Form C-103
Revised July 18, 2013

Devon Energy Production Company, L.P. respectfully requests approval for optional surface casing/drilling plan of 10-3/4" surface casing inside of 13-1/2" surface hole at previously permitted set depths. Devon Energy Production Company, L.P. will circulate class C cement to surface behind the 10-3/4" casing. Devon also request a break test variance. Please see that attached documentation.

Parseltongue 15-10 State Com 23H

Variance Request

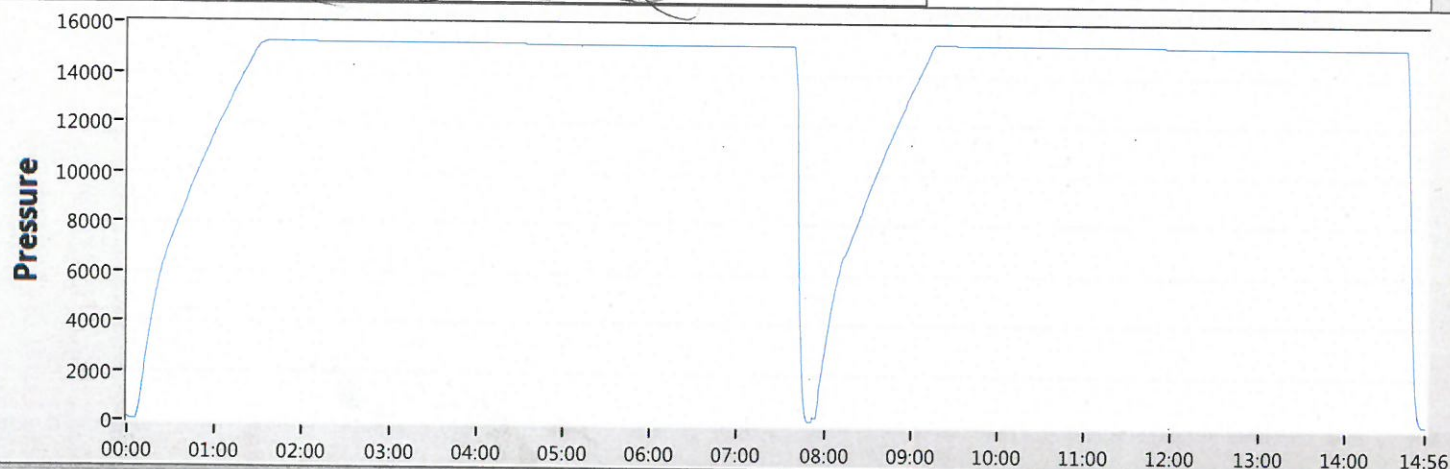
Devon Energy requests to only test BOP connection breaks after drilling out of surface casing and while skidding between wells which conforms to API Standard 53 and industry standards. This test will include the Top Pipe Rams, HCR, Kill Line Check Valve, QDC (quick disconnect to wellhead) and Shell of the 10M BOPE to 5M for 10 minutes. If a break to the flex hose that runs to the choke manifold is required due to repositioning from a skid, the HCR will remain open during the shell test to include that additional break. The variance only pertains to intermediate hole-sections and no deeper than the Bone Springs Formation where 5M BOP tests are required. The initial BOP test will follow OOGO2.III.A.2.i, and subsequent tests following a skid will only test connections that are broken. The annular preventer will be tested to 100% working pressure. This variance will meet or exceed OOGO2.III.A.2.i per the following: Devon Energy will perform a full BOP test per OOGO2.III.A.2.i before drilling out of the intermediate casing string(s) and starting the production hole, before starting any hole section that requires a 10M test, before the expiration of the allotted 14-days for 5M intermediate batch drilling or when the drilling rig is fully mobilized to a new well pad, whichever is sooner. We will utilize a 200' TVD tolerance between intermediate shoes as the cutoff for a full BOP test. The BLM will be contacted 4hrs prior to a BOPE test. The BLM will be notified if and when a well control event is encountered. Break test will be a 14 day interval and not a 30 day full BOPE test interval. If in the event break testing is not utilized, then a full BOPE test would be conducted.
